Re: DEP File #301-1376

Plan Revision Jonatas Storck

58 Massasoit Avenue, Sudbury, MA

PROPOSED HOUSE LOCATION PLAN "58 MASSASOIT AVENUE" SUDBURY, MASSACHUSETTS

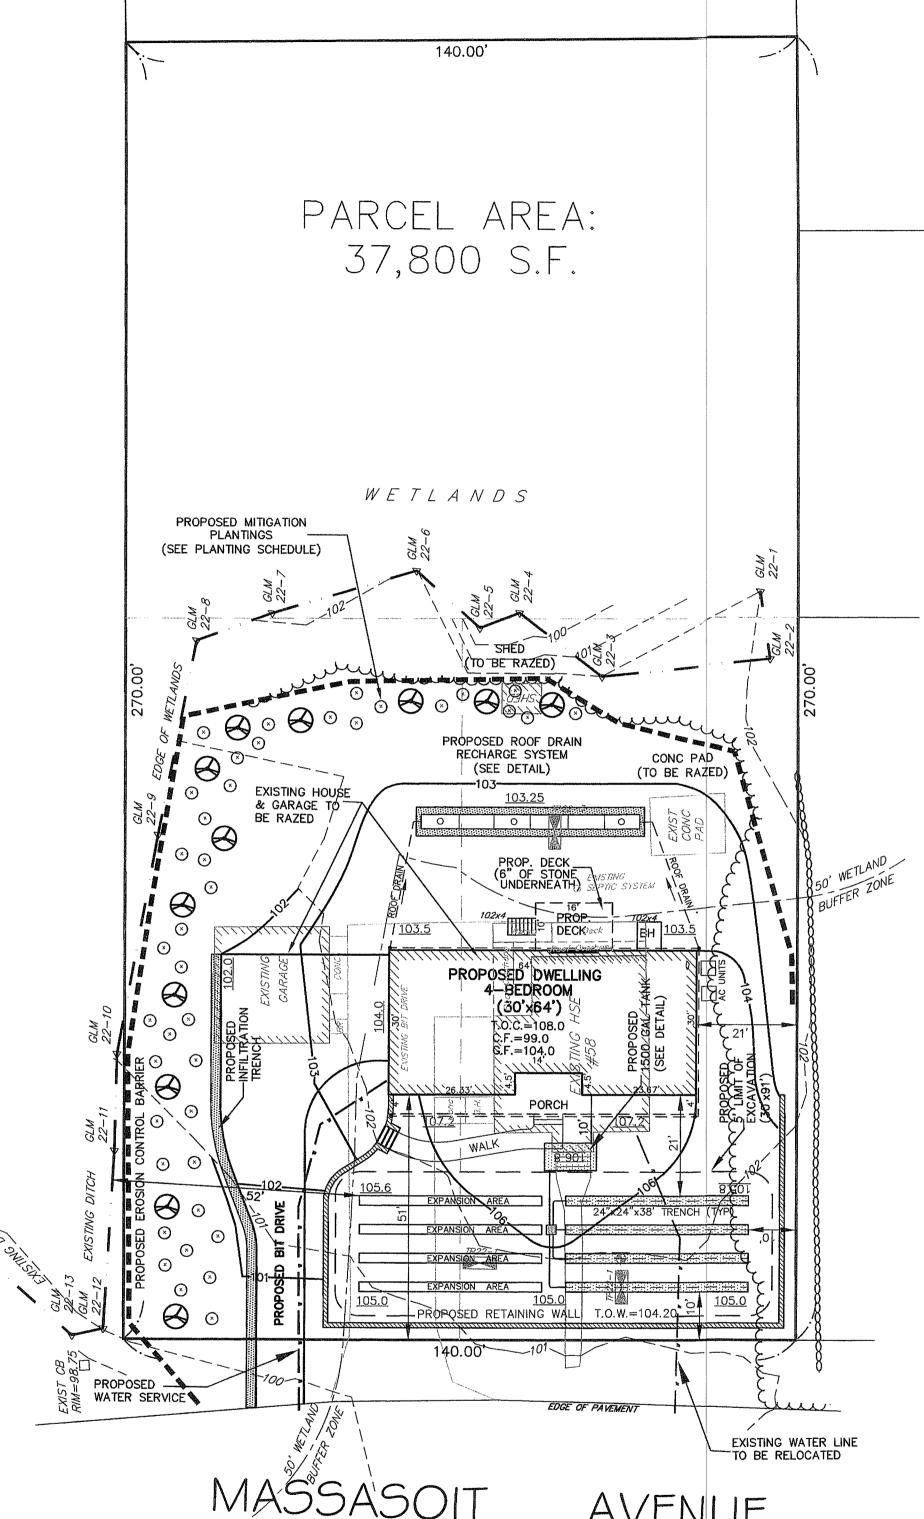
- A reduction of four (4) feet to the house depth. The house footprint was reduced from 34'x64' to 30'x64'.
- The proposed driveway has been reduced in size. The driveway entrance was reduced from 12 feet wide to 10 feet wide.

- A deck and stairs were added to the rear of the house. The deck will have six (6) inches of stone underneath to accommodate stormwater infiltration. Although the deck is not impervious, it was included in the impervious calculations table.

- A bulkhead to the basement has been added to the proposed house.
- Two air conditioning units have been added to the plan.
- The roof drain recharge system has been moved further from the house as suggested by the Town Engineer.

- Additional proposed plantings have been added along the northerly and easterly sides of the existing yard area as mitigation for activity in the wetland buffer zone. The planting schedule has been revised to reflect 40 shrubs and 12 trees.

- The erosion control barrier has been moved closer to the wetlands to surround the debris piles, trash, and invasive species along the northerly and easterly sides of the property.

- In response to concerns regarding existing impervious calculations we have revised the site plan:
 - 1. The area of the existing deck and handicap ramp are now excluded from the impervious area calculations.

- 2. The previous site plan did not reflect the house overhang on the side and rear of the house. The plan has been revised.

- 3. The previous site plan did not reflect the bulkhead and concrete walk on the north side of the house. The plan has been revised.
- 4. The previous site plan did not reflect the concrete pad in front of the garage door. The plan has been revised.
- The septic system is in the rear yard. The cover to the tank/leach pit has been added to the plan.

The original house and garage were constructed in 1952, prior to the current wetland bylaw. This plan revision decreases the footprint of the proposed house and driveway. The project will now result in a 133 square foot reduction in impervious area. In addition, the project will also increase the separation between the house and the wetlands and move the septic system outside the 50-foot wetland buffer zone.

BENCH MARK FRONT HYDRANT BOLT: EL=102.99 (DATUM = ASSUMED)PROPOSED SEWAGE DISPOSAL SYSTEM 58 MASSASOIT AVE

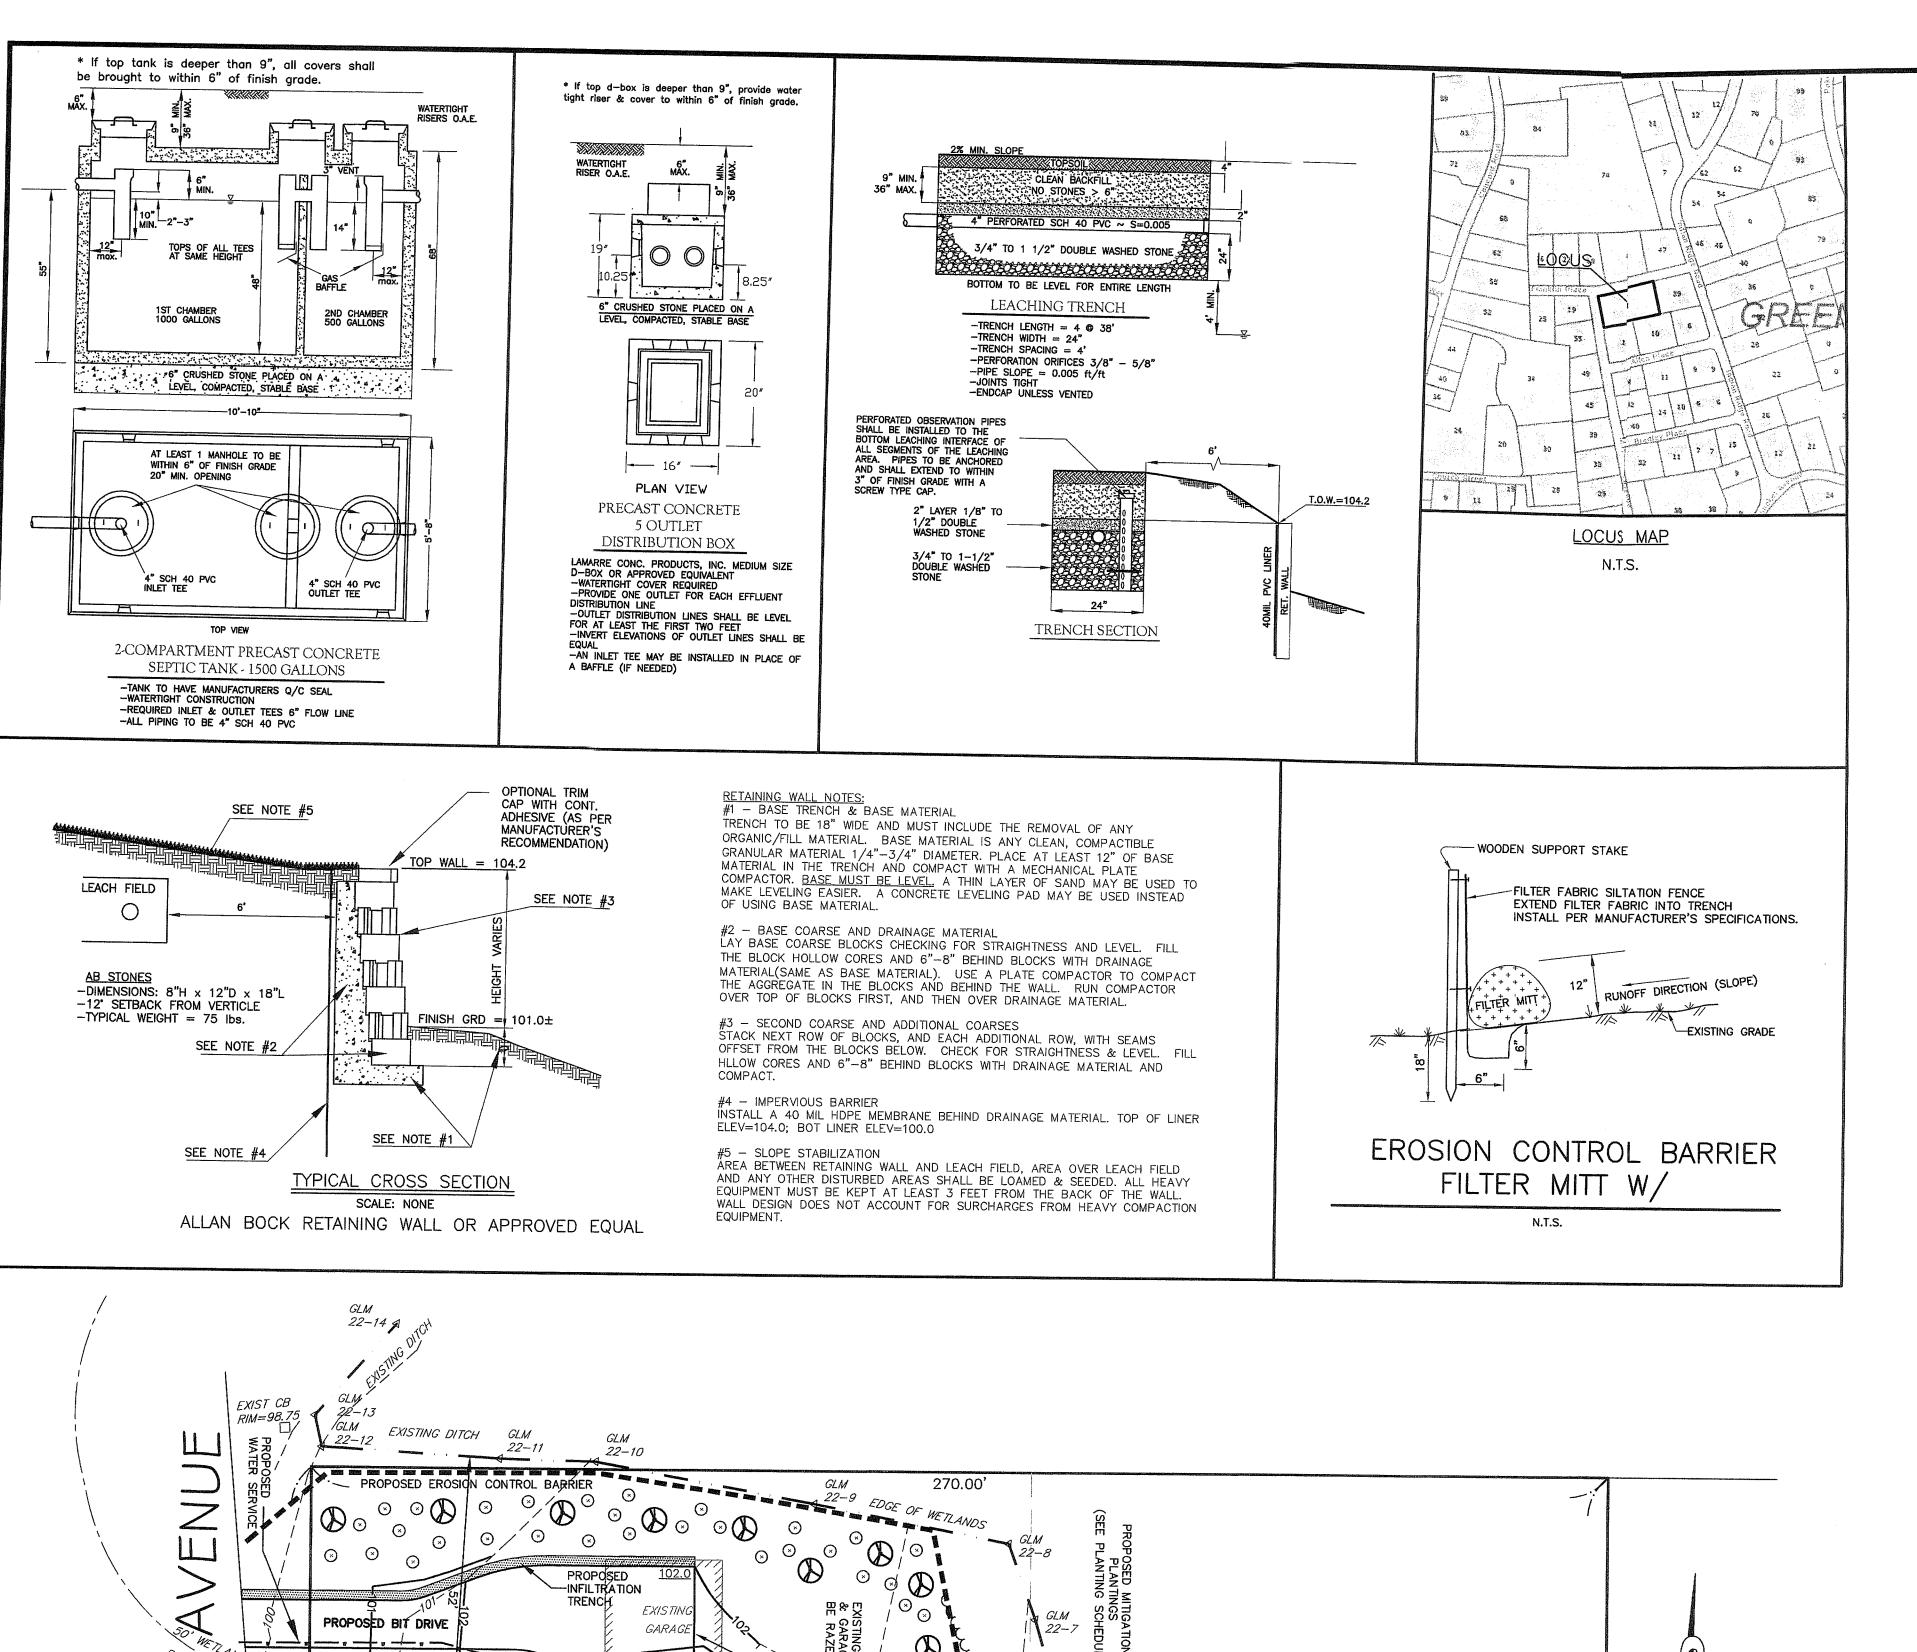
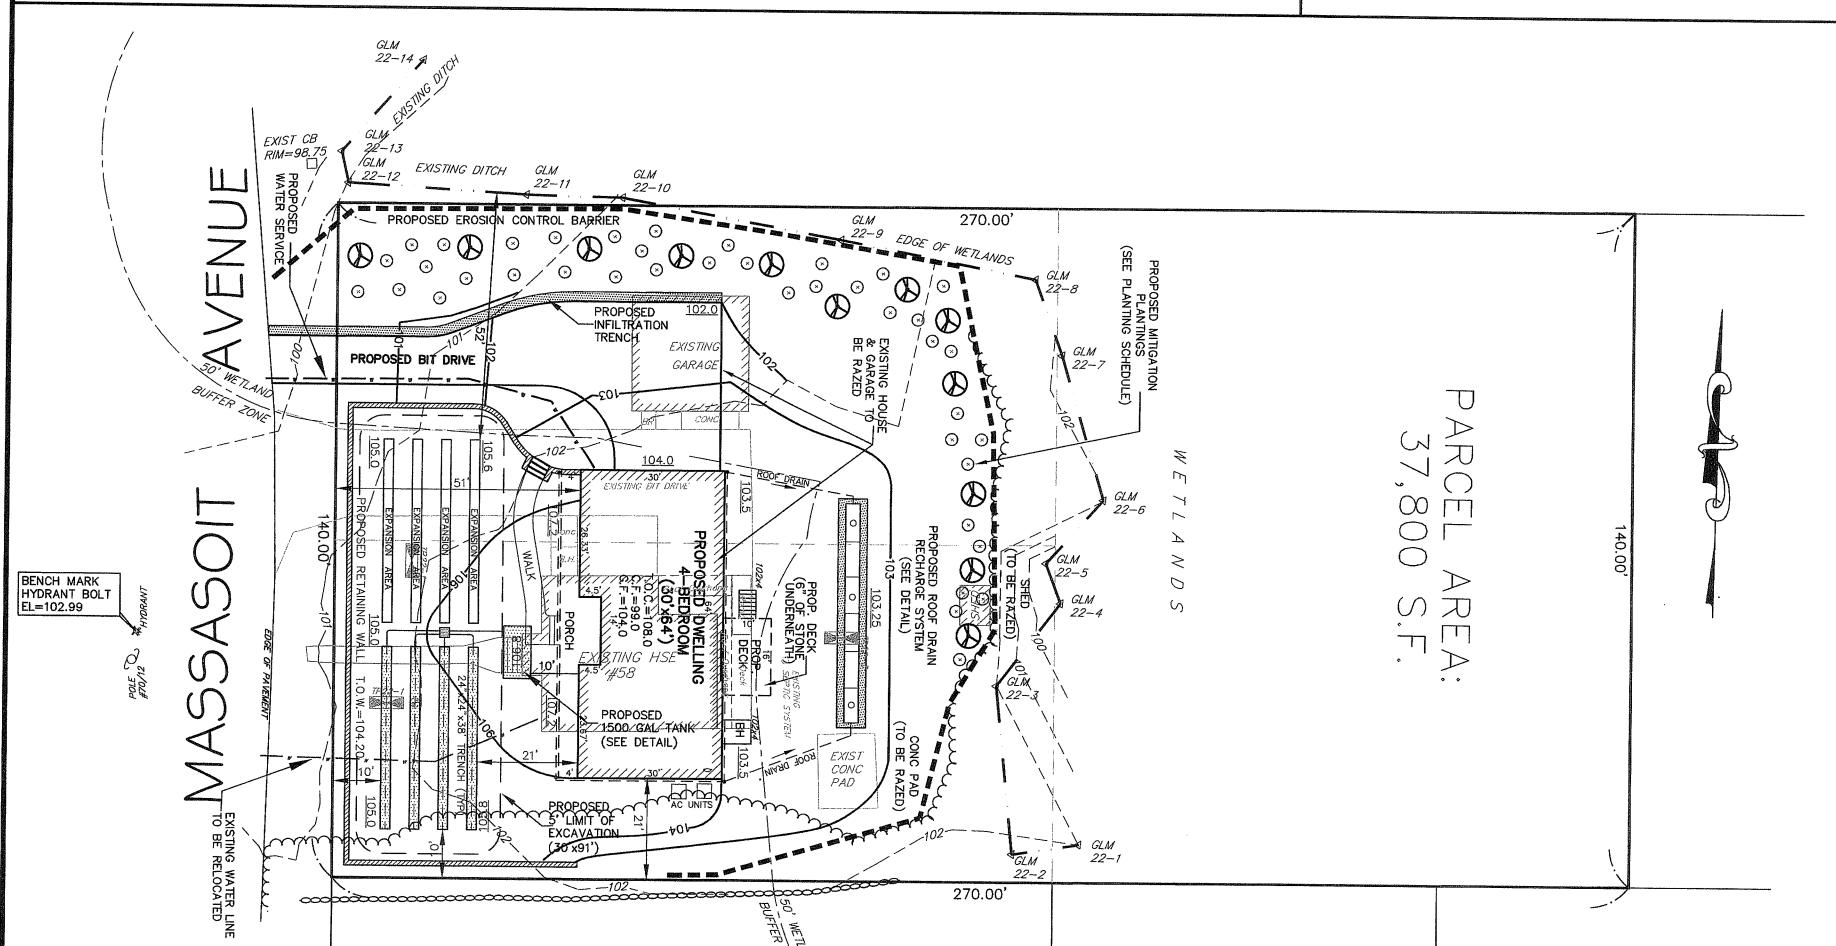
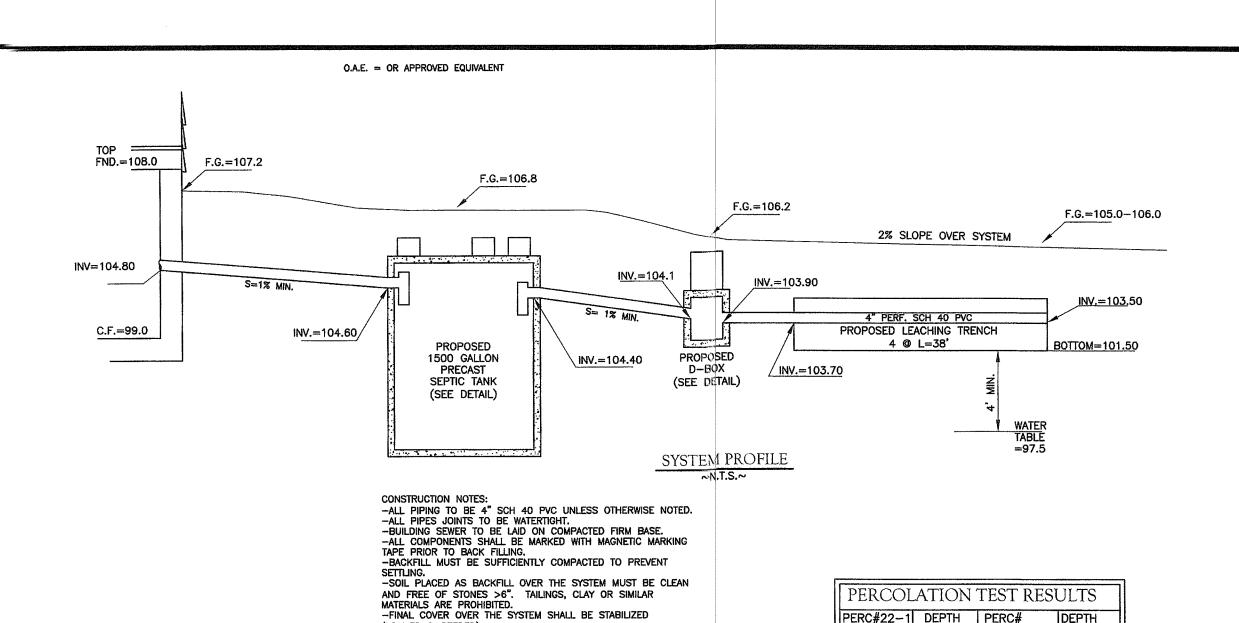
9/16/2022 REDUCE HOUSE,
